# Access Compliance Report

## Public Rights-of-Way

### (Curb Ramps)

Intersection ID: 43364	Main Street: PROSPERITY_VIEW_DR	Cross Street: HIGHLAND_COMMONS_RD	Location: E
ADA ID: 0774165471FB	Ramp Type: PerpDiag	Initial Pass/Fail: Fail	Overall Compliance: No
Severity Score: 8.75			
Codes/Mitigation Info/Possible Solution		Field Measurements/Component Compliance

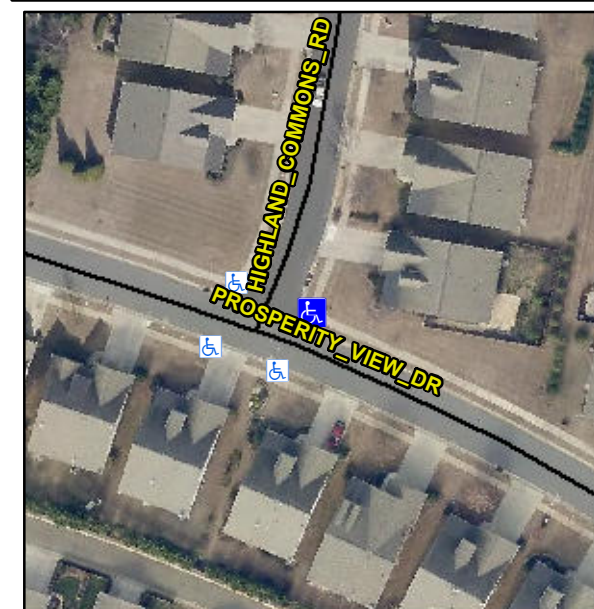
**Not Found, R304.5.1**

Compliance	Description	Data	Compliance	Description	Data
N/A	Ramp Length (in)	48.0	Yes	Ramp Slope (%)	6.9
No	Ramp Width (in)	45.0	Yes	Ramp XSlope (%)	0.9
N/A	Flare Type LT	N/A	N/A	Flare Type RT	N/A
N/A	Flare Slope LT (%)	N/A	N/A	Flare Slope RT (%)	N/A
N/A	Flare Traversable LT?	N/A	N/A	Flare Traversable RT?	N/A
N/A	Landing Length (in)	N/A	N/A	DWS Provided?	N/A
N/A	Landing Width (in)	N/A	N/A	DWS Contrast?	N/A
N/A	Landing Slope (%)	N/A	N/A	DWS Length (in)	N/A
N/A	Landing X Slope (%)	N/A	N/A	DWS Full Width?	N/A
N/A	Landing Curb? (Y/N)	N/A	N/A	DWS Offset (in)	N/A
N/A	Shared Landing?	N/A			
N/A	Gutter Ponding?	N/A	N/A	Gutter Slope (%)	N/A
N/A	Gutter Lip Ht (in)	N/A	N/A	Gutter X Slope (%)	N/A
N/A	Painted X Walk1?	No	N/A	Painted X Walk2?	No
	X Walk 1 Direction	To NW		X Walk 2 Direction	To SW
N/A	X Walk 1 Width (in)	N/A	N/A	X Walk 2 Width (in)	N/A
	X Walk 1 Slope (%)	3.1		X Walk 2 Slope (%)	0.8
	X Walk 1 X Slope (%)	1.0		X Walk 2 X Slope (%)	1.4

**Remove & Replace Curb Ramp With Two New Directional Ramps or Equivalent.**
